ADDENDUM NO. 1 TO PROJECT NO. 44963

**CONSTRUCTION, HVAC AND ELECTRICAL WORK
REPLACE COOLER/FREEZERS
MESS HALL, BUILDING NO.16
ELMIRA CORRECTIONAL FACILITY
1879 DAVIS STREET
ELMIRA, NY**

March 18, 2016

SK-S001

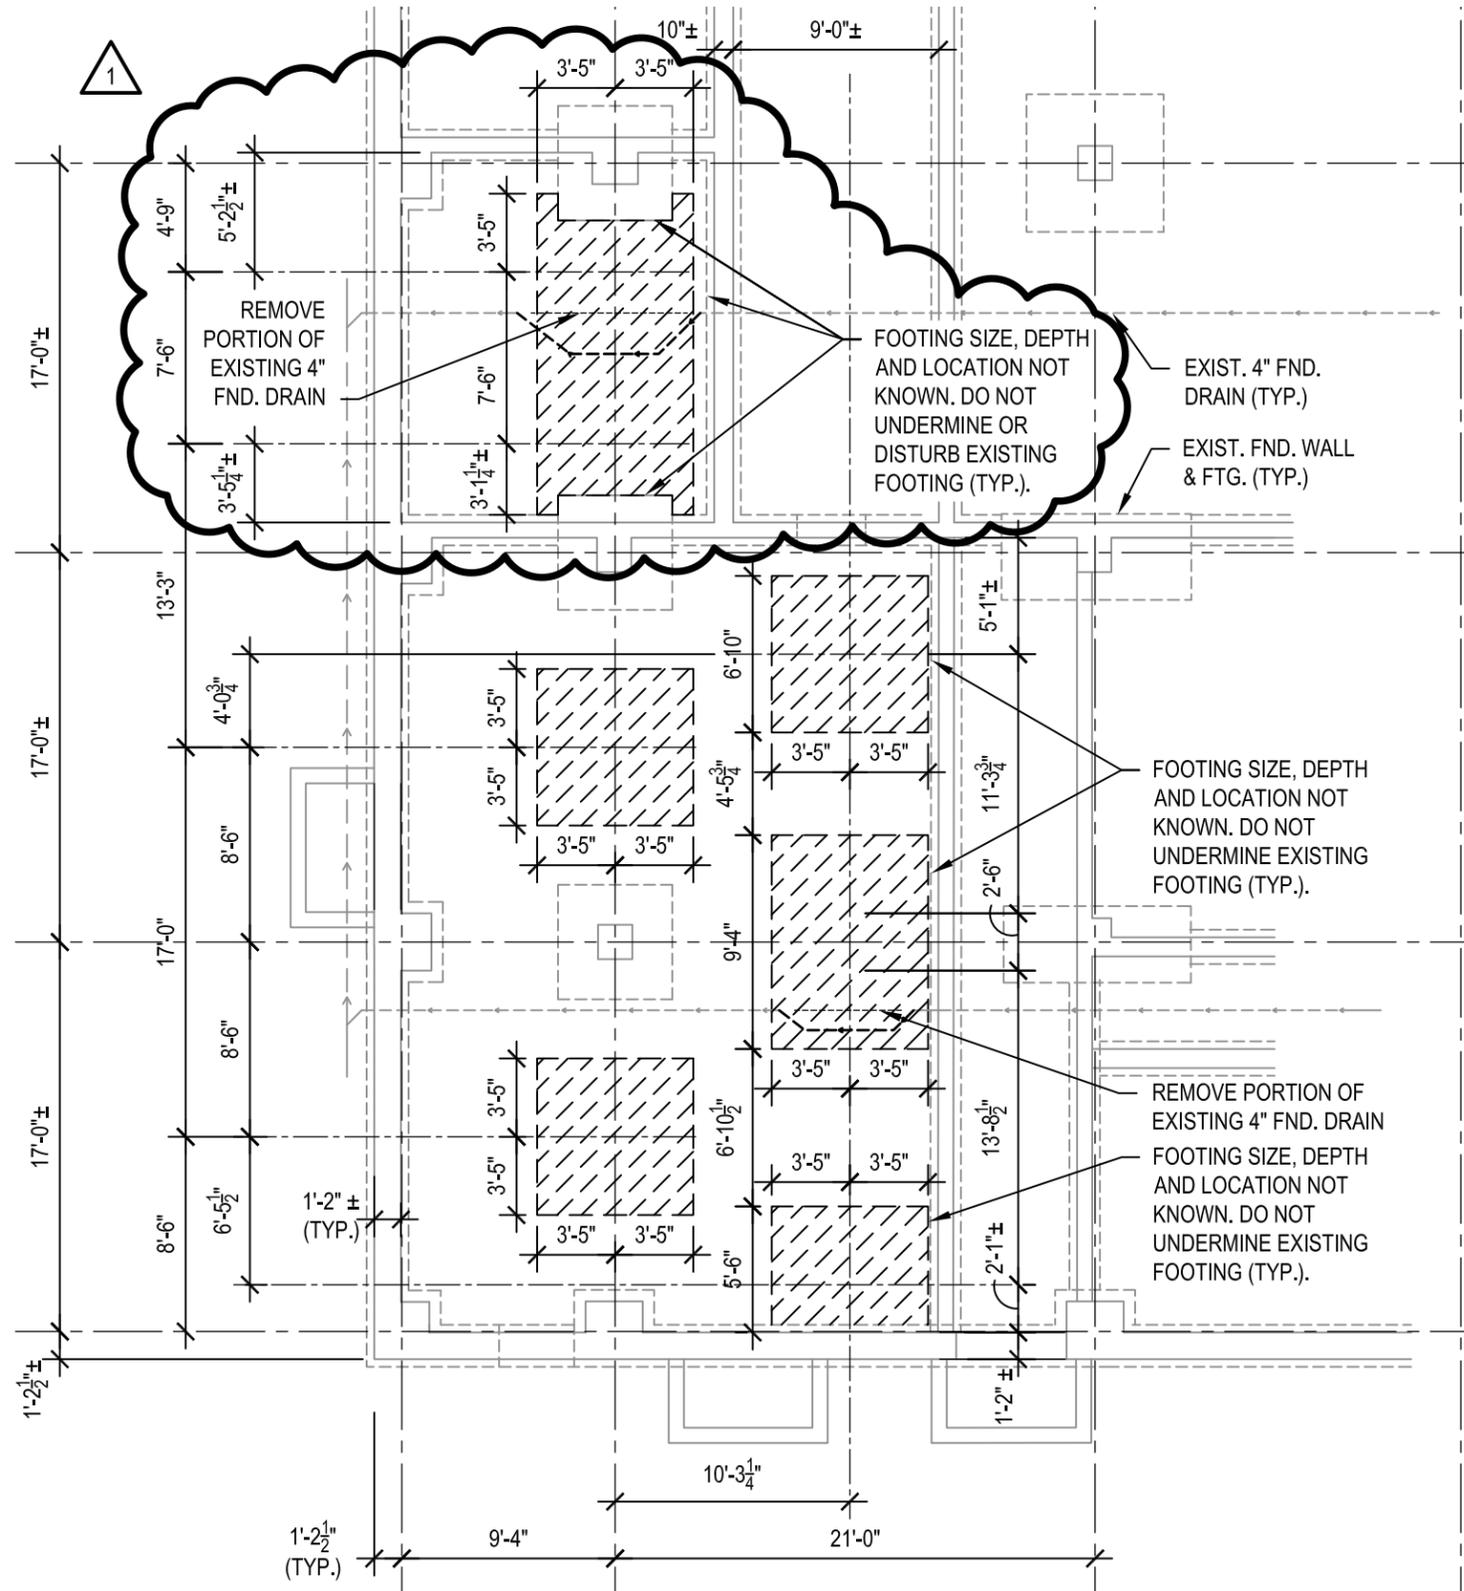
1. Drawing No. S-101:
 - a. PARTIAL FOUNDATION DEMOLITION PLAN, SOUTH END: Refer to attached Drawing SK-S001 for revised Foundation Demolition Work-South End. This drawing will replace the demolition work indicated

SK-S003

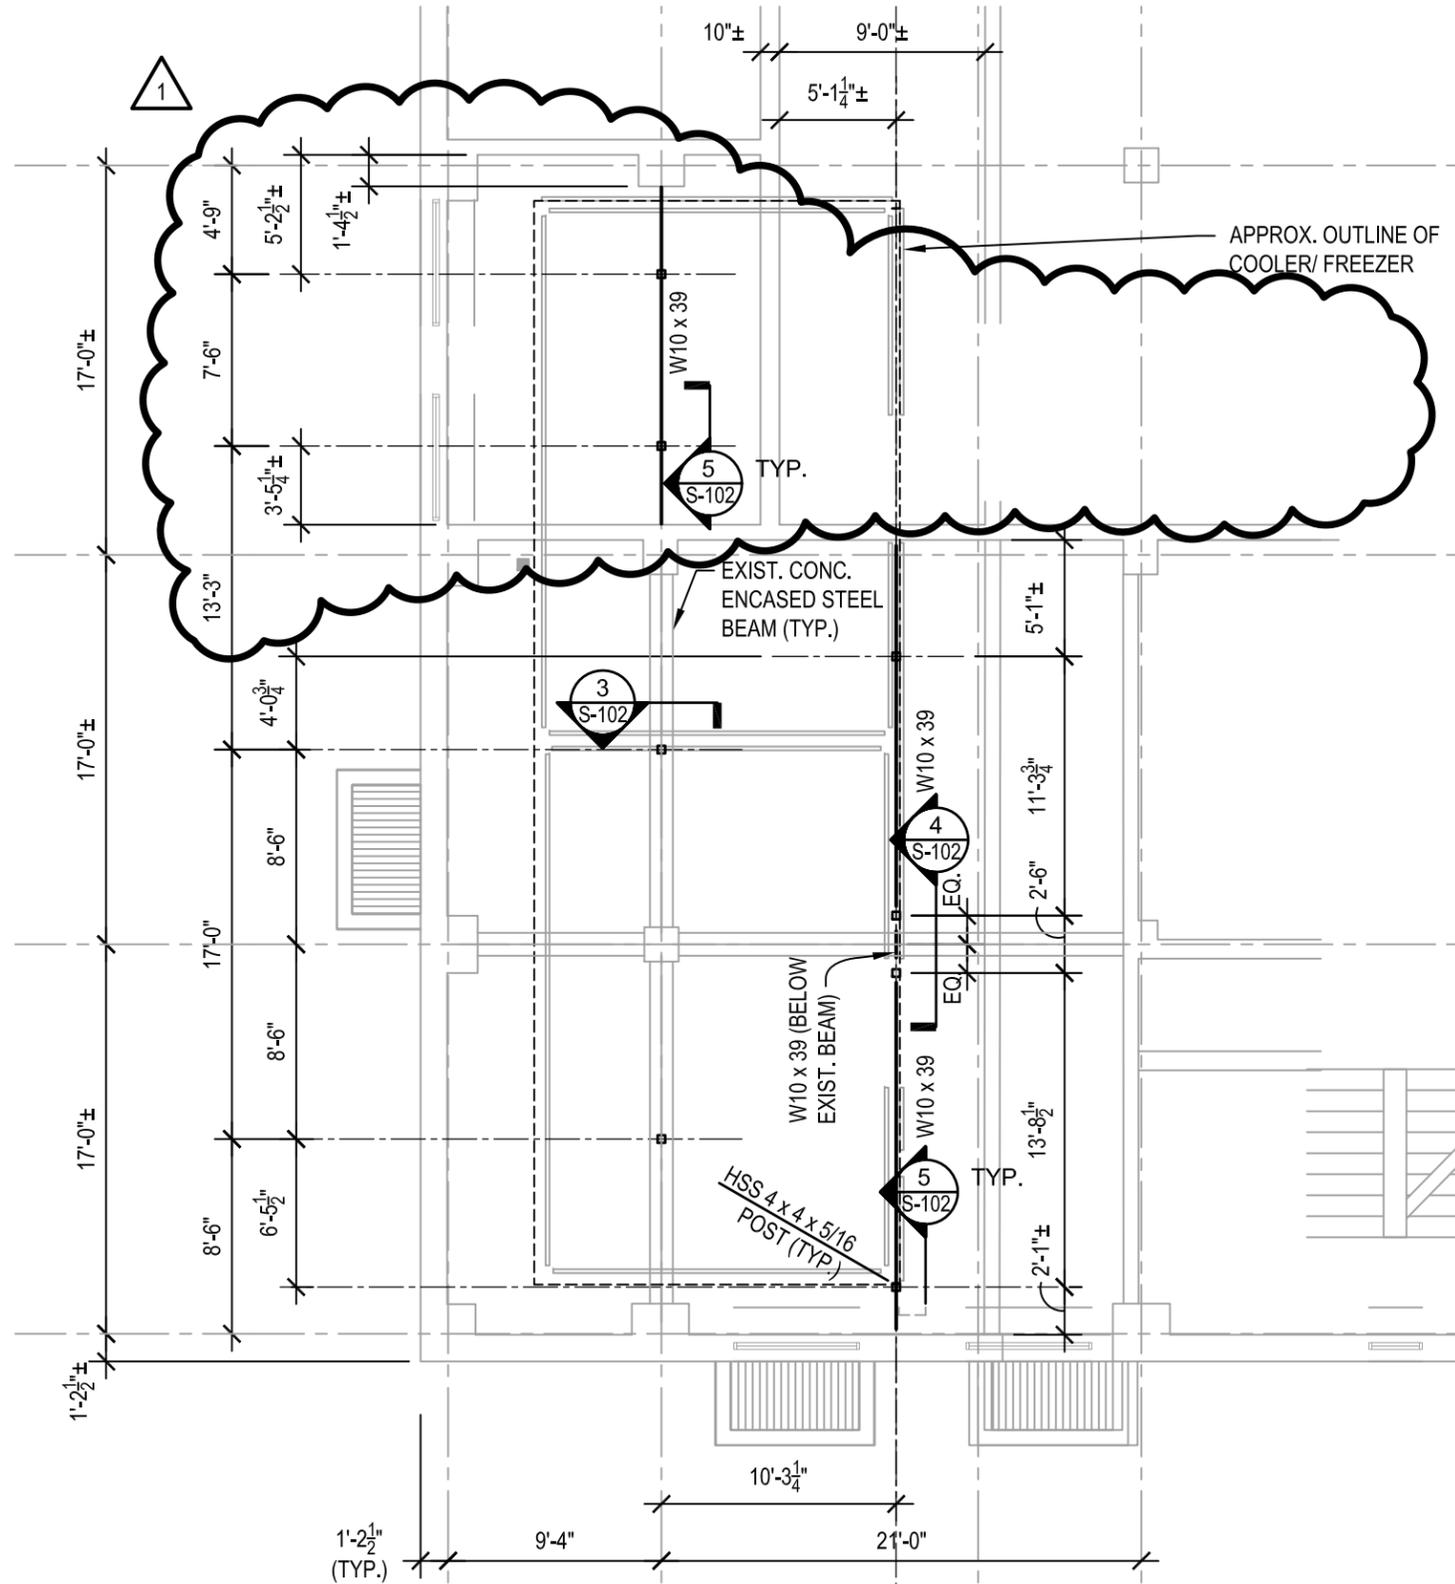
2. Drawing No. S-102:
 - a. PARTIAL FIRST FLOOR FRAMING PLAN, SOUTH END: Refer to attached drawing SK-S-002 for revised First Floor Framing Plan-South End. This drawing will replace the Structural Work indicated.
